Subject: Annual Inspection Report
Stevenson/Bridgeport Municipal Airport

Annual Inspection Report Stevenson/Bridgeport Municipal Airport Stevenson, Alabama

May 22, 2007

Photo 1 – Approach Violations Runway 5

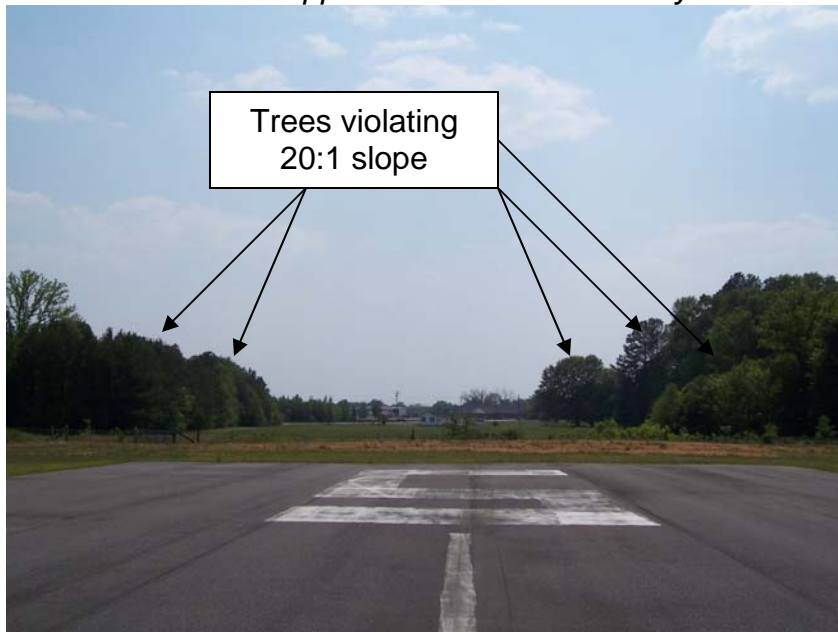
- Runway 05 – The required 20:1 approach slope is violated by trees along the South side of the approach. These trees were cleared along the line of the Approach/Departure Path, but the trees have grown and now violate the required clear area.

- Runway 05 – Trees violate the required 20:1 approach slope along the North side of the approach. The required 20:1 approach slope is reduced to 1:1.
- See Appendix 2 for locations of the violations.

- The violating trees must be removed throughout the Approach/Departure Path. The tree line along the South side now violates the required approach. There are fewer trees in the Approach/Departure Path than within the Displaced Approach. The clearing of the Approach/Departure Path will enable the airport to remove the present displaced threshold and meet licensing requirements on this runway end. The required displacement to provide a clear 20:1 slope is 855 feet.

Photo 2 – Violations of approach slope Runway 23

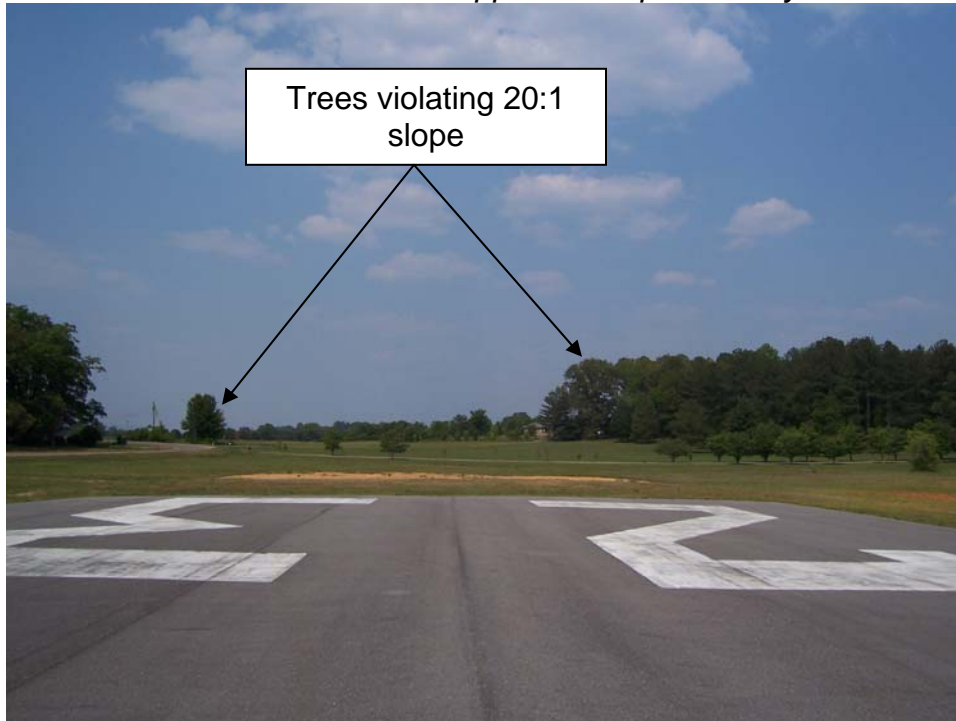
- Runway 23 – Trees violate the required 20:1 approach slope and reduce the slope to 6:1.
- See Appendix 3 for locations of the violations.

- The trees that violate the required 20:1 approach slope must be removed from within the Approach/Departure Path.
- The present 1048 foot displacement of the runway can be reduced to a displacement of 873 feet and increase the available runway for landing from the East. The 873 foot displacement will place the end of the 1000 foot approach on the airport property line. This displacement is intended to be a temporary solution until the City can clear the trees on adjoining property that violate the licensing requirements.

STEVENSON/BRIDGEPORT MUNICIPAL AIRPORT REQUIREMENTS FOR STATE AIRPORT LICENSE

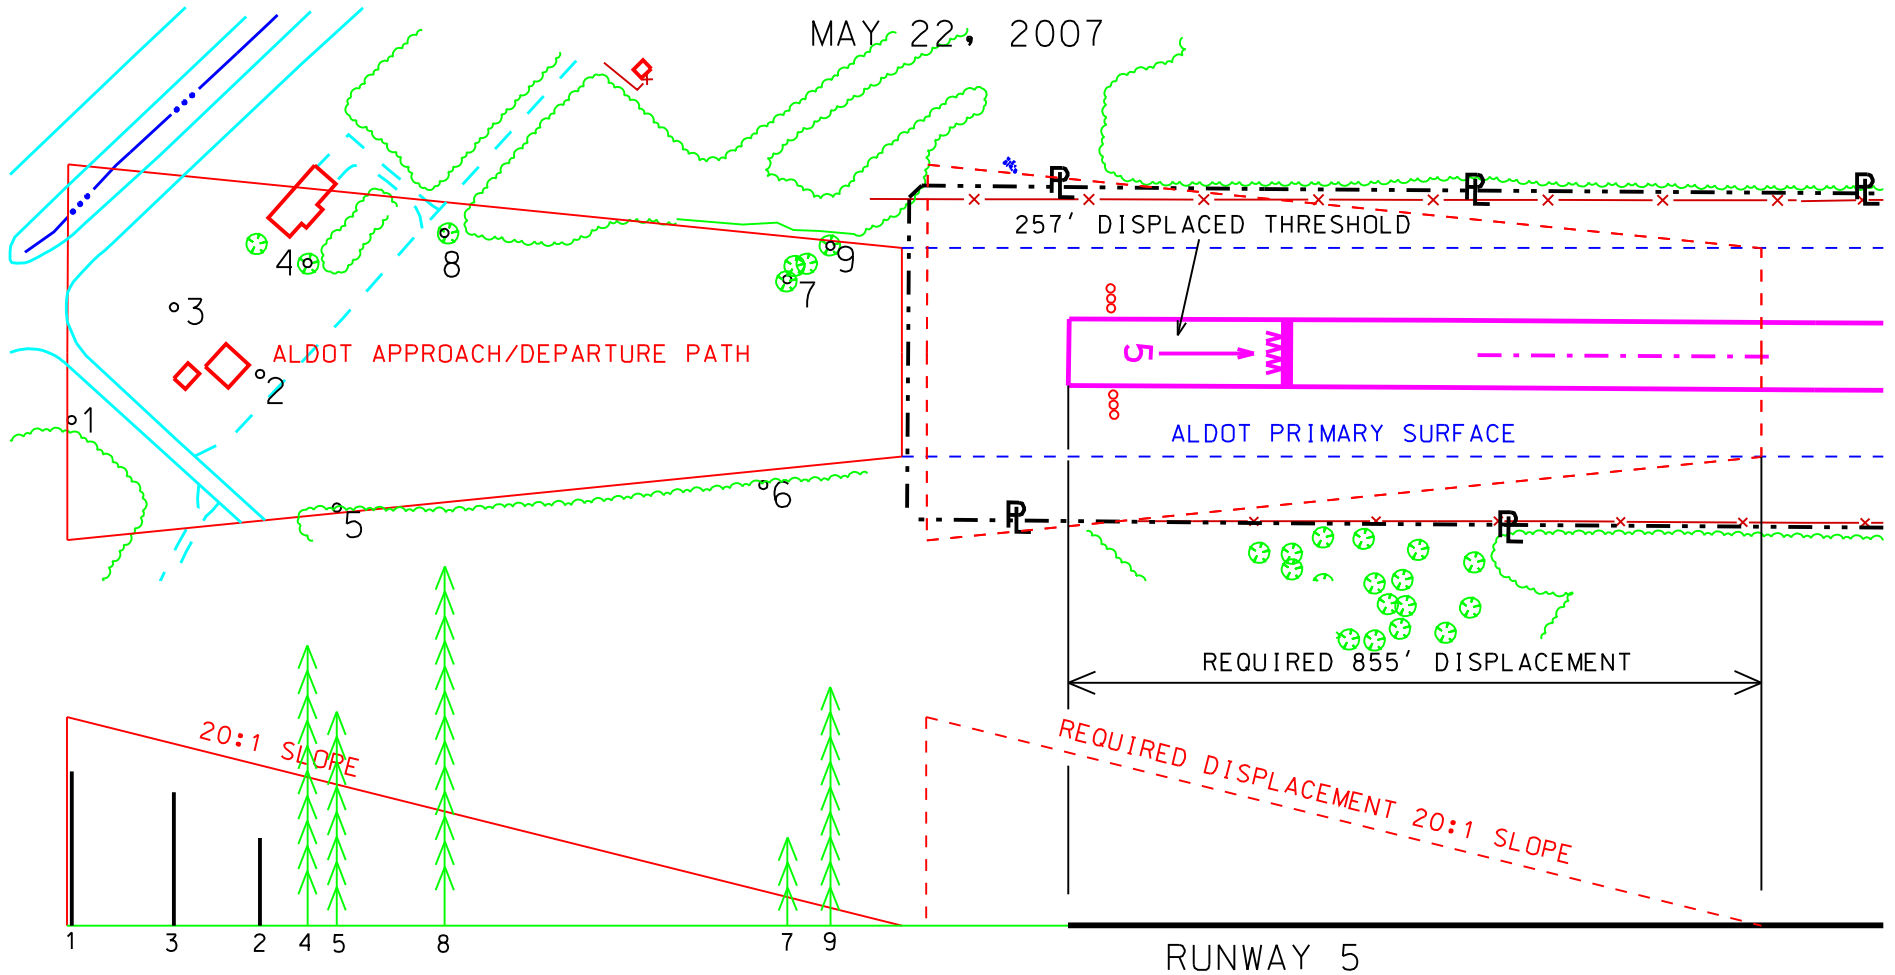
VIOLATIONS:

| 4. +67' TREE

912' FROM RUNWAY END
107' FROM CENTERLINE
10:1 SLOPE | 8. +86' TREE
748 FEET FROM RUNWAY END
143' FROM CENTERLINE
6:1 SLOPE |

| 5. +51' TREE LINE

757' TO 877' FROM RUNWAY END
143' FROM CENTERLINE
12:1 SLOPE | 9. +57' TREE
285' FROM RUNWAY END
128 FEET FROM CENTERLINE
1:1 SLOPE |

| 7. +21' TREE

337' FROM RUNWAY END
88' FROM CENTERLINE
6:1 SLOPE | NOTE: #8 AND #9 DELINEATE A TREE LINE |

REQUIREMENTS FOR STATE AIRPORT LICENSE

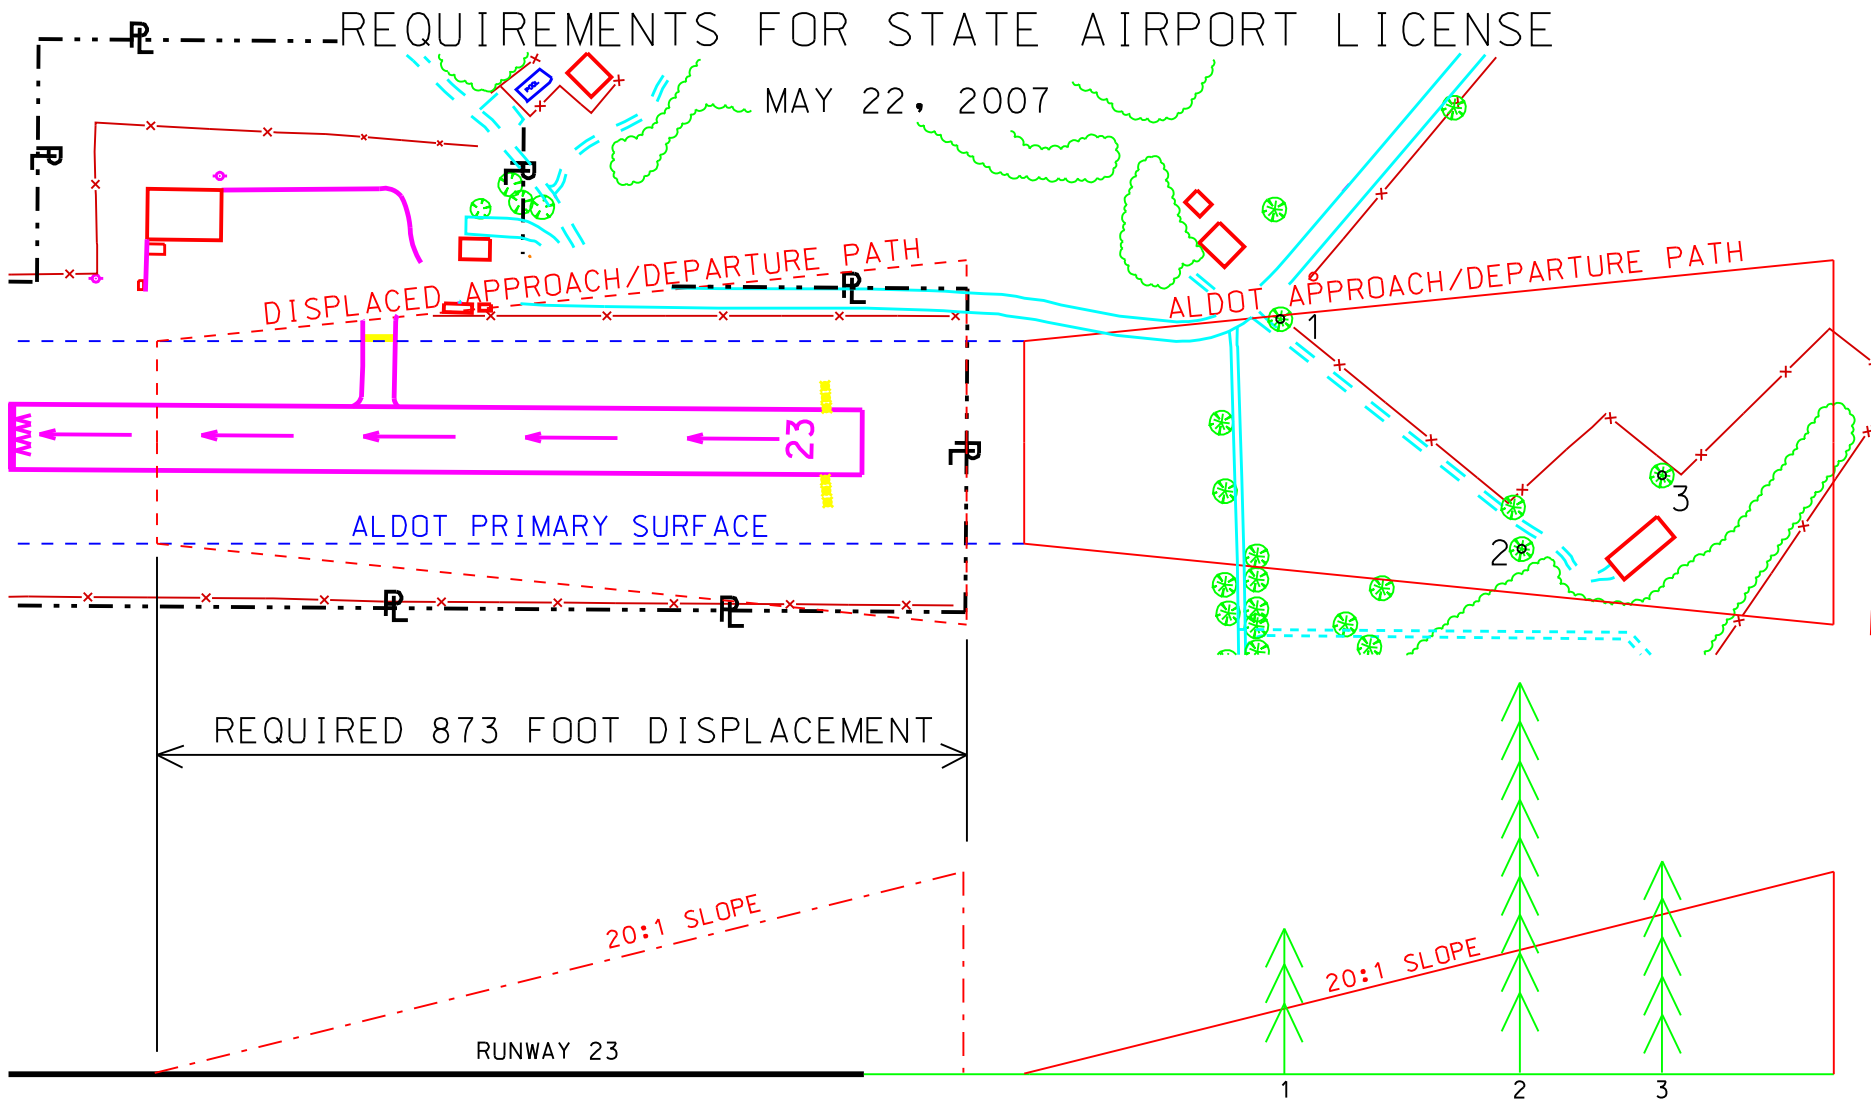
VIOLATIONS:

1. +36' TREE
510' FROM RUNWAY END
156' FROM CENTERLINE
8:1 SLOPE
2. +96' TREES
807' FROM RUNWAY END
137' FROM CENTERLINE
6:1 SLOPE
3. +52' TREES
989' FROM RUNWAY END
38' FROM CENTERLINE
15:1 SLOPE
